DART AEROSPACE LTD	Work Order:	161125
Description: Crosstube Assembly, Mid Fwd	Part Number:	D206-667-147
Inspection Dwg: D206-667-147 Rev: A		Page 1 of 2

DART AEROSPACE LTD HAWKESBURY, ONTARIO, CANADA	
DRAWING NO. D206-667-147	REV. A SHEET 1 OF 4
TITLE CROSSTUBE ASSY (206L MID FWD)	SCALE NTS
COPYRIGHT © 2010 BY DART AEROSPACE LTD THIS DOCUMENT IS PRIVATE AND CONFIDENTIAL AND IS SUPPLIED ON THE EXPRESS CONDITION THAT IT IS NOT TO BE USED FOR ANY PURPOSE OR COPIED OR REPRODUCED IN ANY FORM OR BY ANY MEANS WITHOUT WRITTEN PERMISSION FROM DART AEROSPACE LTD.

DRAWING NO. D206-667-147	TITLE CROSSTUBE ASS'Y (206L MID FWD)	REV. A	DART AEROSPACE LTD ENGINEERING ORDER		D.E.O. NO. D206-667-147-A-1	SHEET NO. SHEET 1 OF 1	SCALE NTS
DRAWN <i>qp</i>	CHECKED <i>ASS</i>	MFG. APPR. <i>JB</i>	APPROVED <i>MD</i>		DE APPR. <i>///</i>		
DATE 11.07.15	DATE 11.07.20	DATE 11.07.21	DATE 11/07/21		DATE 11.07.21

DRAWING NO. D206-667-147	TITLE CROSSTUBE ASS'Y (206L MID FWD)	REV. A	DART AEROSPACE LTD ENGINEERING ORDER	D.E.O. NO. D206-667-147-A-2	SHEET NO. SHEET 1 OF 1	SCALE NTS
DRAWN AJS	CHECKED	MFG. APPR.	APPROVED	DE APPR.		
DATE 12.08.02	DATE 12.08.02	DATE 12.08.02	DATE 12.08.02	DATE 12.08.02	DATE 12.08.02

DETAIL P
BONDING STRAP INSTALLATION 2 PL

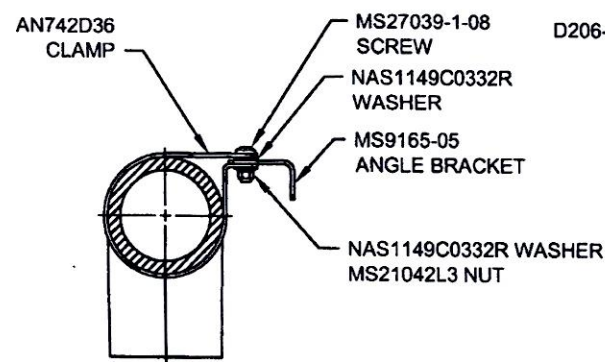
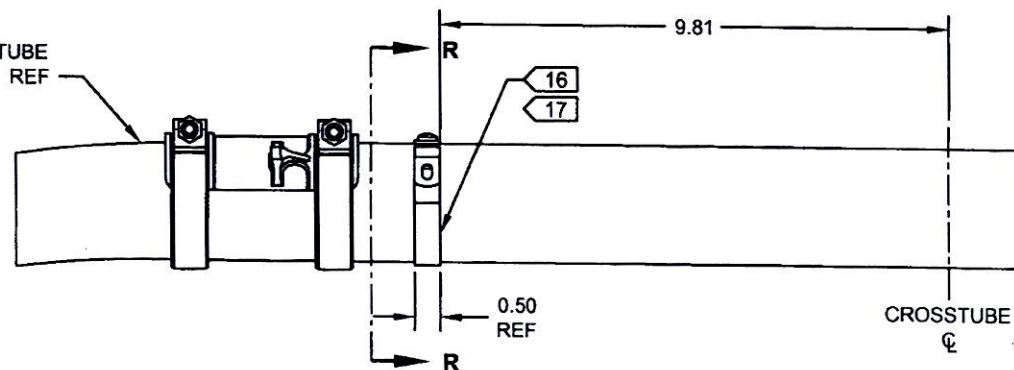
ADD ELECTRICAL GROUNDING STRAP

ITEM	QTY -147	PART NUMBER	DESCRIPTION
1	X	D206-667-147	CROSSTUBE ASSEMBLY (206L MID FWD)
10	2	AN742D36	CLAMP
11	2	MS9165-05	ANGLE BRACKET
12	2	MS21042L3	NUT (OR MS21042-3)
13	2	MS27039-1-08	SCREW
14	4	NAS1149C0332R	WASHER (OR AN960C10L)

- 16) MASK AREA UNDER CLAMP PRIOR TO PAINTING
- 17) SEAL EDGES WHERE AN742D36 CLAMP MEETS WITH THE CROSSTUBE USING SIKAFLEX-241/-291 OR MIL-S-8802 CLASS B2 OR PROSEAL 890 SEALANT
- 18) PERFORM RESISTANCE CHECK TO ENSURE MAX RESISTANCE IS 10 MILLIOHMS
